ADDENDUM NO. 02

SDC Modular Classroom Building at Colton High School

DSA No: 04-122921 File No: 36-6 RCA Project No. 3-79-02

Sheet #: **ASK-2.1**

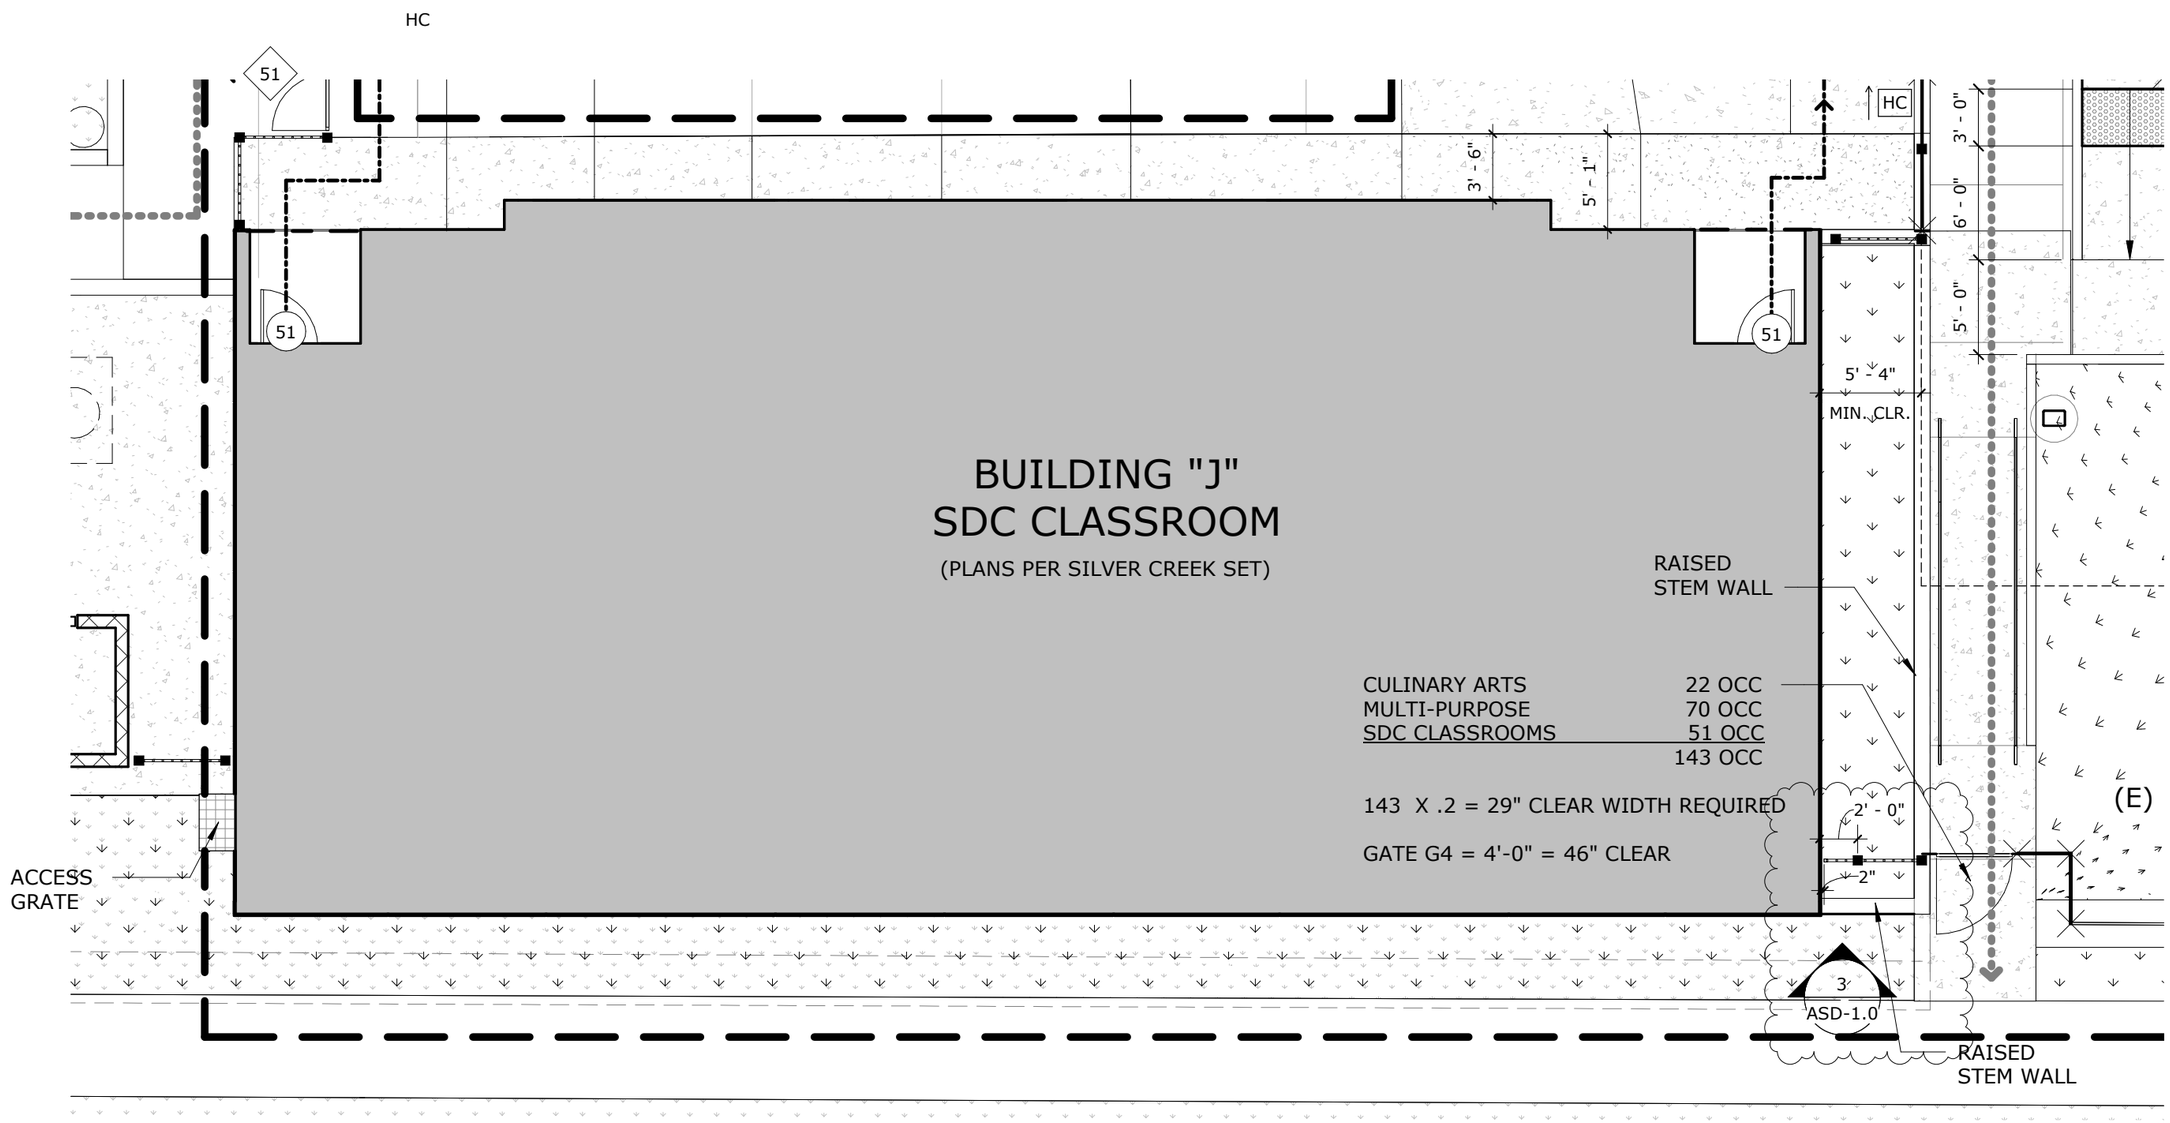
Item No. 2.2 Reference Sheet AS-2.1 – ENLARGED SITE PLAN
2.2.1 Revise per clouded areas of attached sketch ASK-2.1:
a. Detail 1 – New fence layout.

Sheet #: **ASK-2.2**

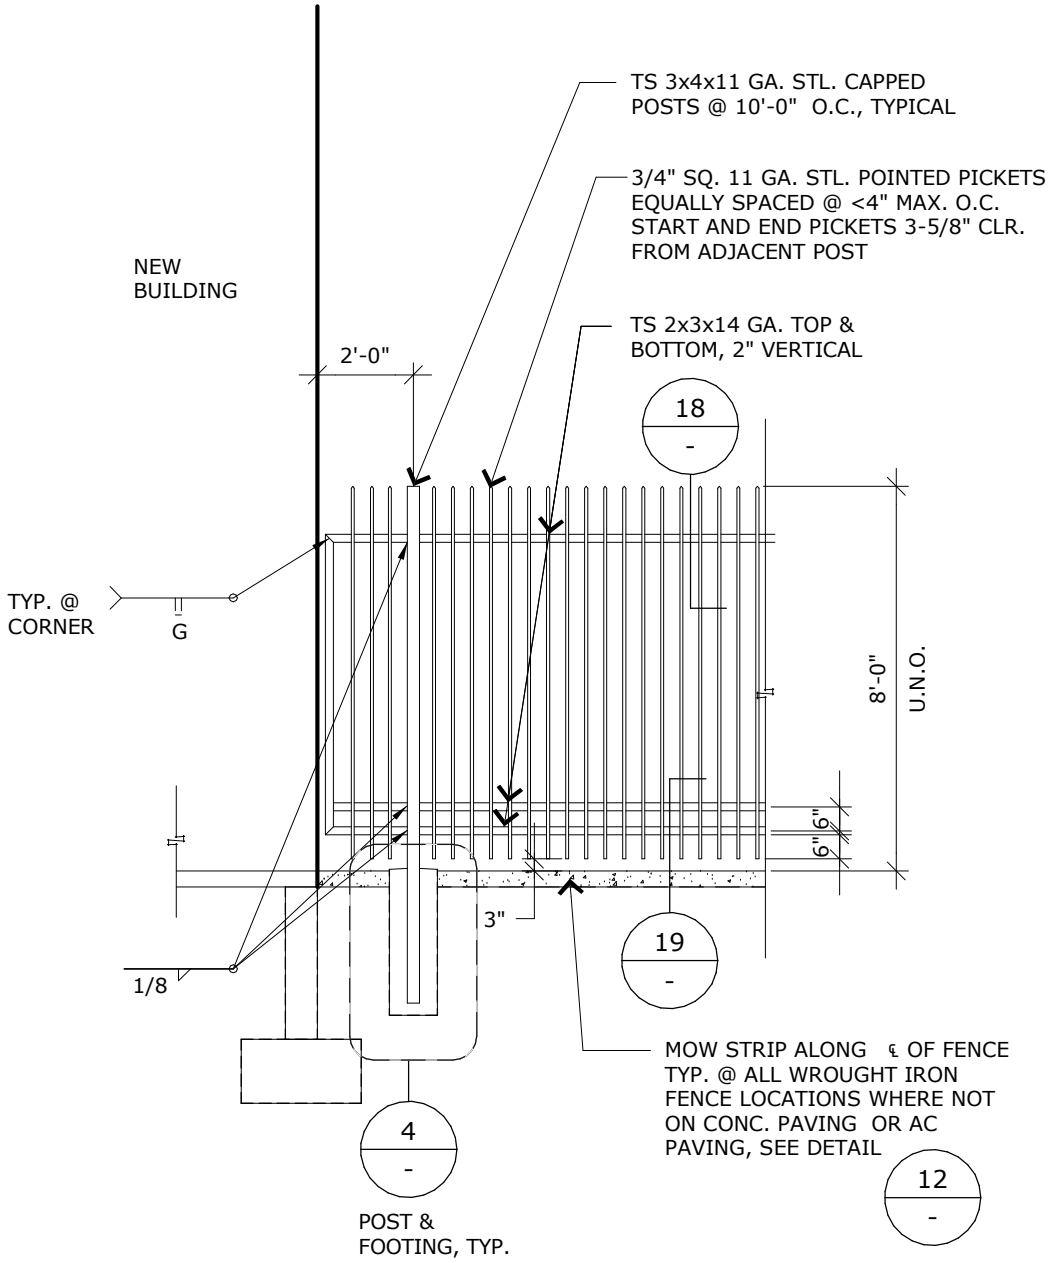
Item No. 2.3 Reference Sheet ASD-1.0 – SITE DETAILS
2.3.1 Revise per clouded areas of attached sketch ASK-2.2:
a. Detail 3 – New fence elevation at Building

Sheet #: **ASK-2.3**

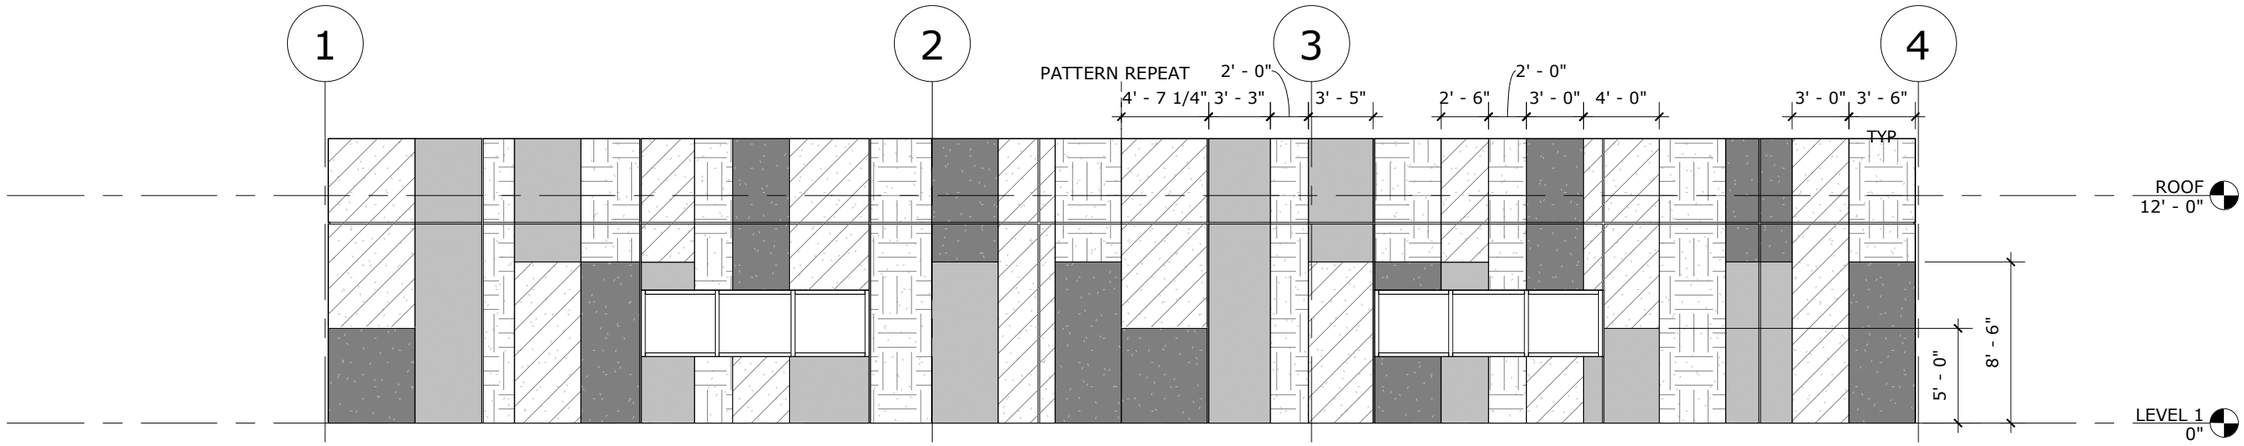
Item No. 2.4 Reference Sheet A-4.01 – EXTERIOR ELEVATIONS

2.4.1 Revise per clouded areas of attached sketch ASK-2.3:

a. Revise South Elevation color pattern

Sheet #: **EXH-1.0**

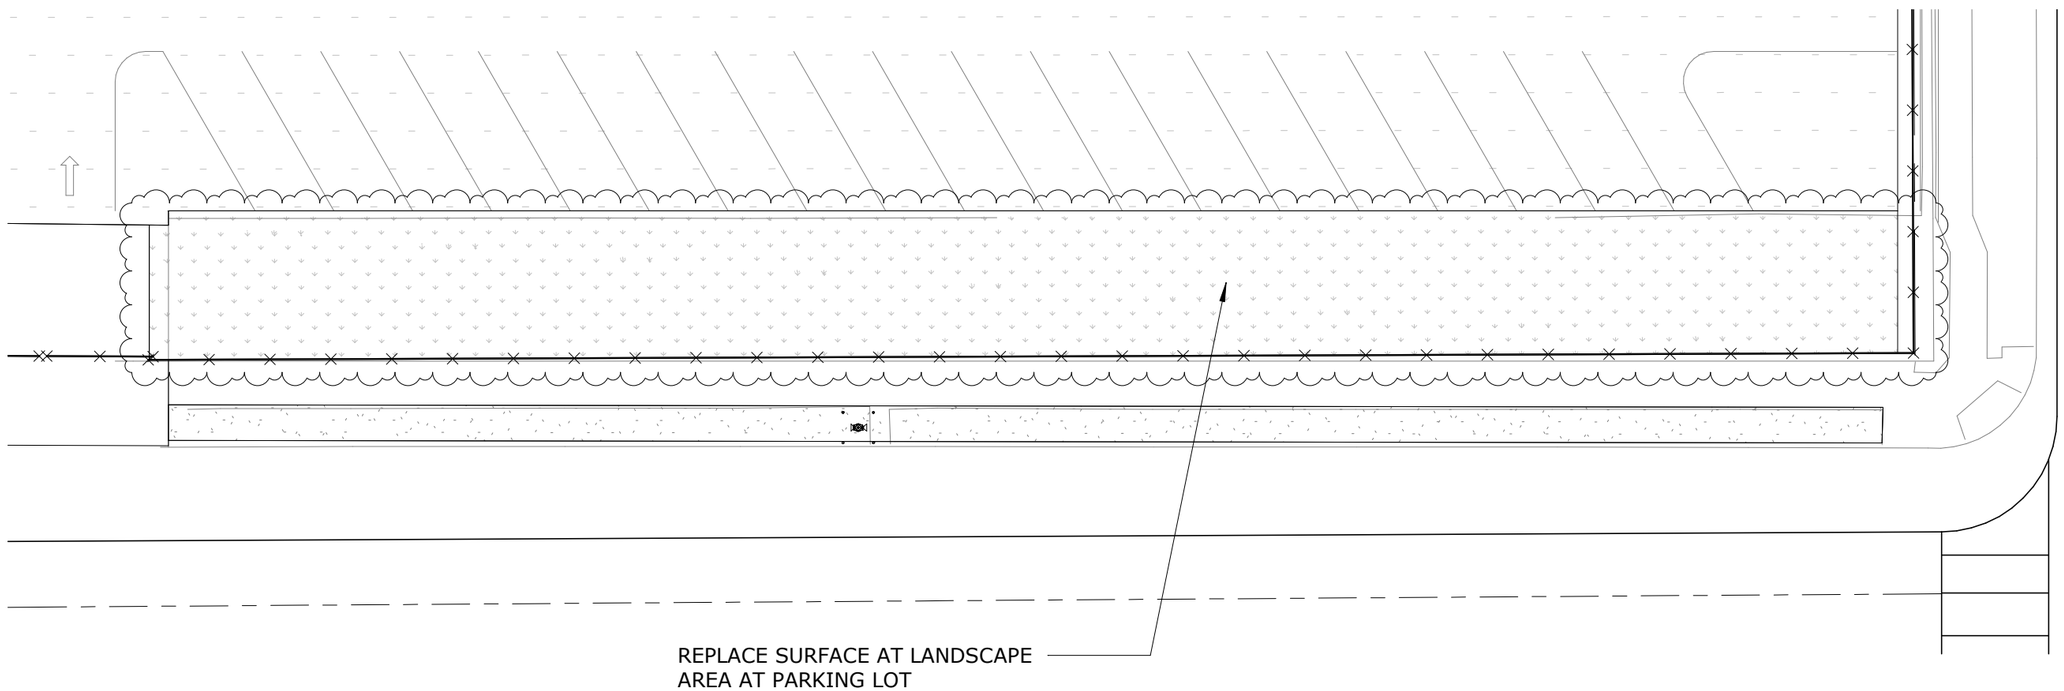
Item No. 2.5 Reference Sheet AS-2.1 – ENLARGED SITE PLAN

2.5.1 Revise per clouded areas of attached sketch EXH-1.0:

a. Revise site plan to replace turf area at parking lot
